**City of Bellevue
Development Services Department
Land Use Staff Report**

Proposal Name: Stanton Slope Stabilization

Proposal Address: 5515 142nd Avenue SE

File Number: 17-119904-LO

Figure 1

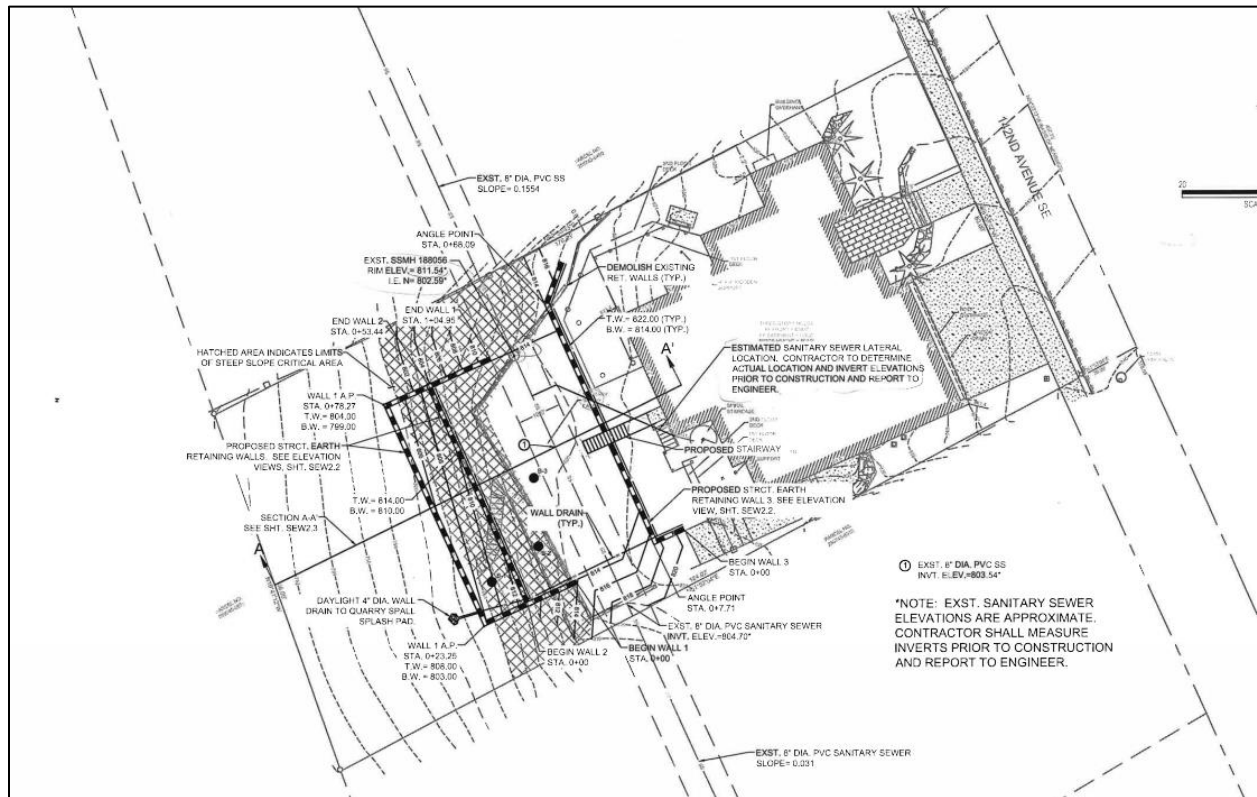
Changes to the design of the walls were requested to avoid placement of structures over the City's sewer main and within the easement area. The project was also requested to limit disturbance to the site topography and vegetation below the steep slope area.

Given that the steep slope is artificial and that no significant vegetation is impacted, staff concur that the proposed stabilization system is a feasible alternative. All evaluations and recommendations contained in the geotechnical studies and used in the city's evaluation of the proposal were completed by a licensed qualified professional. Any design or documentation submitted to the City as part of future permit applications related to this project must follow the recommendations of the project geotech. **See Conditions of Approval in Section X of this report.**

All disturbance resulting from construction is required to be restored. A conceptual restoration plan was submitted that identifies the work area and states that planting will occur based on the planting templates in the City's Critical Areas Handbook. This plan does not provide any detail on the number of plants or the specific species that will be installed. The total disturbance area indicated on the plans is approximately 2,300 square feet which is the square footage that is required to be replanted following construction. Based on the planting templates and this planting area there should be 23 trees, 121 shrubs, and 2,000 ground covers. A final planting plan is required to be submitted that provides the plant species and quantities to be installed which must be at least as dense as the planting described here. **See Conditions of Approval in Section X of this report.**

Response: As described previously, approximately 2,300 square feet of disturbance area is required to be restored with trees, shrubs, and ground covers. This planting is required to be monitored for three years. A maintenance and monitoring plan is required to be submitted with the clearing and grading permit to describe the three years of monitoring, goals, and objectives. A maintenance surety is required to be provided which is 100 percent of the cost estimated to maintain and monitor the plants for five years. **See Condition of Approval in Section X of this report.**
